HL-LHC Engineering Change Request #2159673

**REDUCTION OF Q1 BEAM SCREEN COOLING TUBE
DIAMETER FROM Ø16 MM TO Ø10 MM**

N. Kos TE-VSC

TCC #77, 06 - 06 - 2019

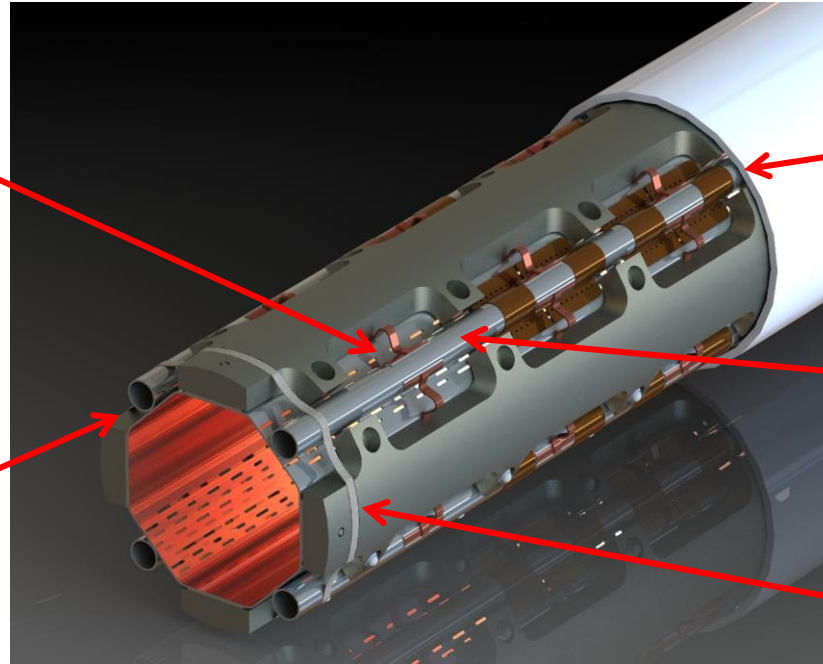
Reasons for proposed change

Suppression of specific Q1-type interface plate for thermal links

Suppression of specific Q1-type pumping slot shield

Reduced cooling tube rigidity simplifies tooling for cooling tube welding.

Design of elastic support ring to be modified (cost neutral)

Suppression of dedicated 16 mm bending tooling and less space issues due to smaller bending radii.
